SDCI # 3027128 8803 M L King Jr Way South FULL DESIGN REVIEW / DESIGN RECOMMENDATION

# Link Townhomes / East

Tuesday January 9, 2018 - 8:00 PM

### **DESIGN RECOMMENDATION RESPONSE**

### DESIGN CONCEPT, ARCHITECTURAL CHARACTER + MASSING (1AI)

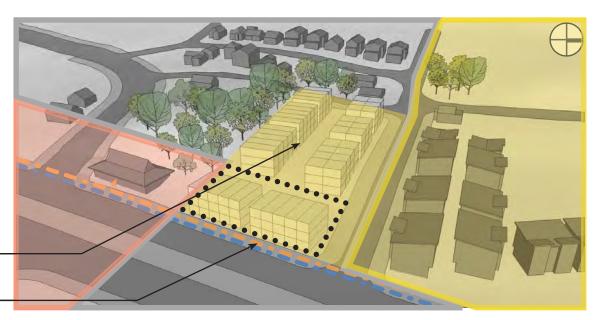
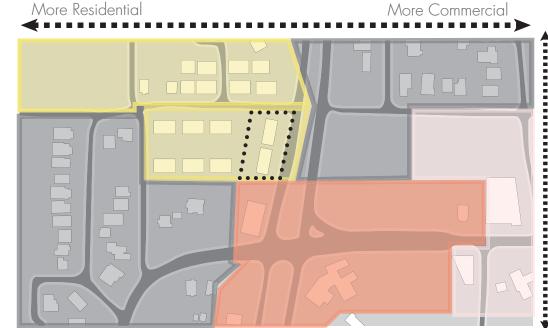
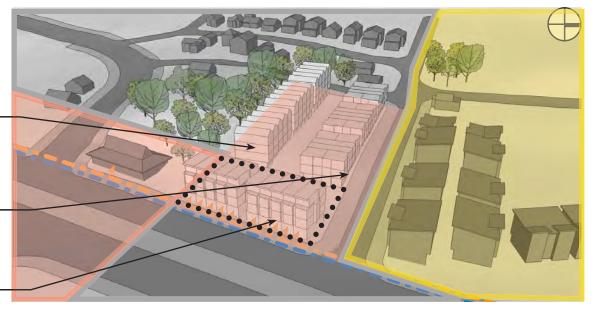
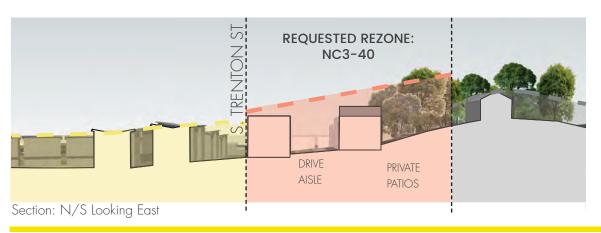
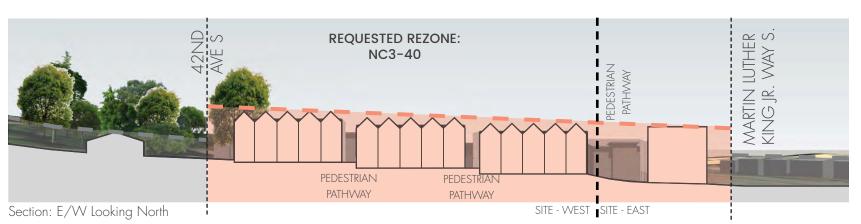
Same roof form and number of levels did not differentiate the different townhome buildings -

Townhomes in EDG preferred option did not active the commercial edge of the site-

Individually stepped gabled roofs of the southern townhome buildings are a more traditional roof form better transtioning to single-family homes. -

Townhomes along Trenton continue the commercial nature of the live-work bldgs, but the reduced number of floors better matches the proportion of the townhomes across the street.

Live-work units provide a commercial use along MLK & an opportunity for pedestrian interaction along the route between the light rail station & Chief Sealth Trail

### M. L. KING JR WAY FRONTAGE (2B)

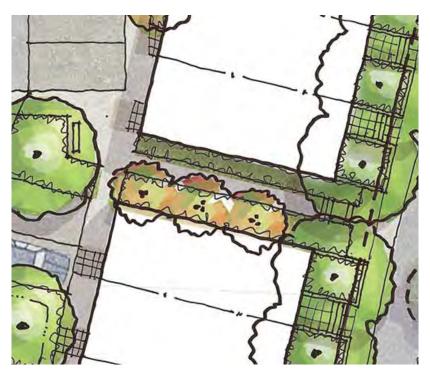
The board felt the massing forms abutting M L King Jr. Way South were successful from a ground-level perspective but there should be special attention paid to the roof forms and the centralized common entry along M L King Jr Way South.

Compared to the EDG meeting the central stair space is more activated with the live-work mail at the bottom of the stairs and the townhome mail at the top. Large windows from the live-work units provide more visibility to the space. Stepped concrete planters better define the edge of the stairway. The heavy landscaping at the bottom of the stairs in the EDG preferred option creates a more private space while the hardscape in the current design provides opportunities for more seating and groups to gather.

### M. L. KING JR WAY FRONTAGE (2A + 3A)

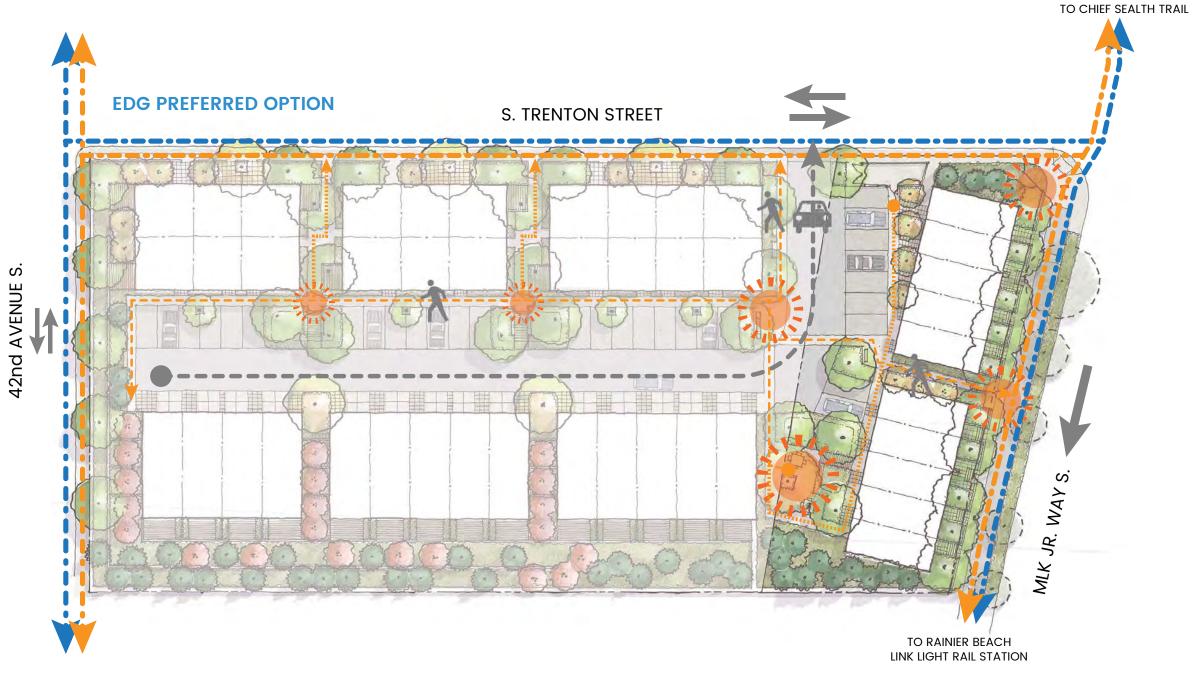
The varied roof form becomes the focal point of the design instead of the elements at the base of the building or bays that are enhancing the pedestrian experience.

The individual units are defined and the building does not read as a whole. The roof massing also appears top heavy.

### DESIGN CONCEPT, ARCHITECTURAL CHARACTER + MASSING AND VEHICULAR/BICYCLE PARKING AND ACCESS (1AII)

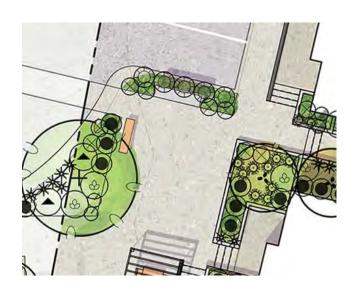
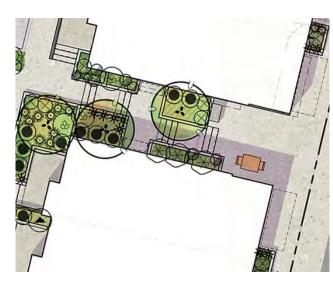
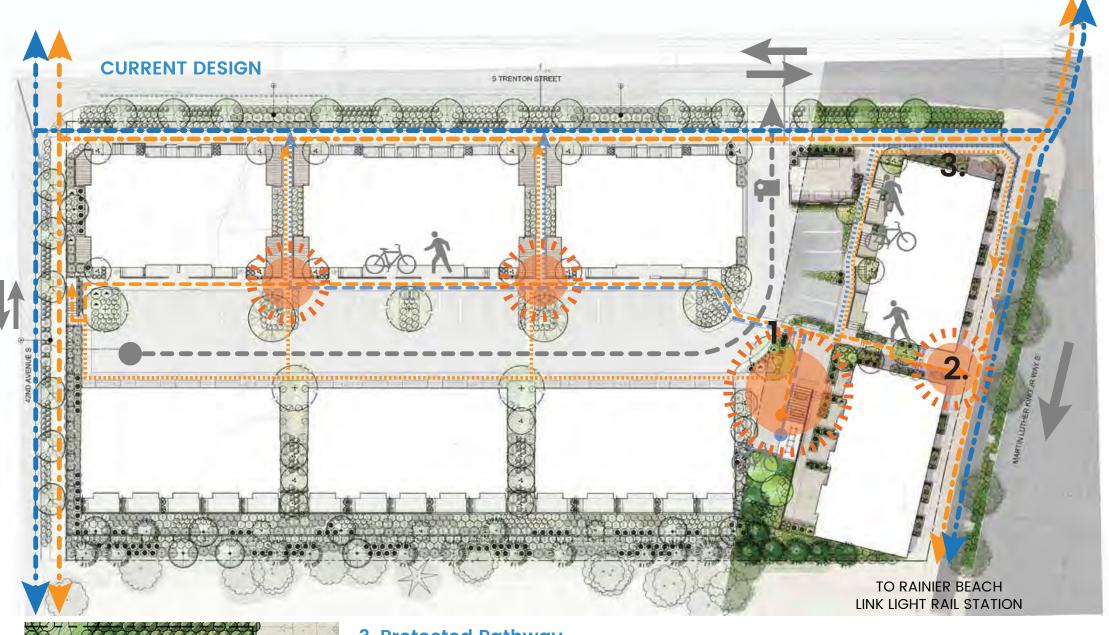
The board voiced concern the site circulation is primarily vehicular focused and that emphasized connective opportunities for pedestrian and cyclists is important. They stated it was an aspect of the design needing to be strengthened.

PL2.B - SAFETY AND SECRURITY PL2.D - DESIGN AS WAYFINDING PL4.B.3 - BIKE CONNECTIONS The primary East-West path was strengthened by having it pass through the common area versus between the parking stalls as previously. Another protected connection was also added at the North end of the site. It serves as an accesible ramp to get from the "work" spaces of the live-work units to the waste storage enclosure, but may also be used by pedestrians and bicyclists alike.

Instead of passing throuh the parking spaces as presented in the EDG site plan the primary route passes through the common area where the townhome mail and bike shelter are located.

The stairway features a more commercial edge with more hardscape for potential seating and is activated by placing the livework and townhome mail at the top and bottom.

The accesible route from the live-work units to the waste storage enclosure is slightly elevated above the sidewalk and separated by a concrete curb. It is an alternative path for pedestrians and bicyclists versus using the central stair.

### **SOUTH TRENTON STREET FRONTAGE**

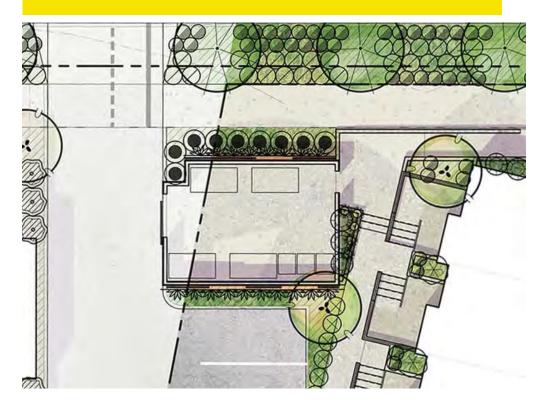
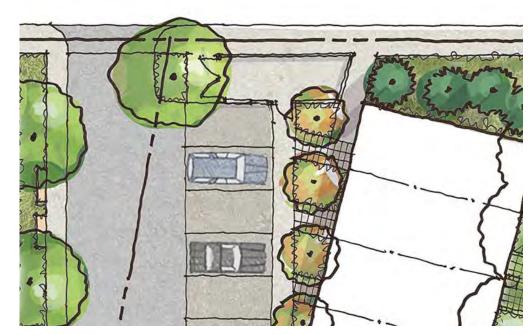
The board observed the waste storage area near the vehicular entrance abutting South Trenton Street may be impactful to the public realm along the street and advised the applicant give focused attention to the concern. They requested specifics concerning waste staorage, location, access and feedback from Seattle Public Utilities should be presented at the next meeting.

Locating the trash enclosure at the driveway entrance is the most feasible as no access is allowed from MLK Jr. Way South and there is a large grade change between the site and 42nd Avenue South. This also permits the service providers to access the waste storage enclosure because it is less than 55' away from the truck, eliminating the need for a staging area along the sidewalk which would be highly visible to passing pedestrians. The waste storage enclosure will be finished in high quality materials consisting of a board formed concrete base, overlapping stained cedar siding, and perforated metal panels to allow for ventilation. Compared to the EDG preferred option the current trash & recycling enclosure is set back from the sidewalk providing space for a 4'-6" wide planting area.

The trash enclosure has been sent to SPU. Received preliminary approval. Awaiting final approval.
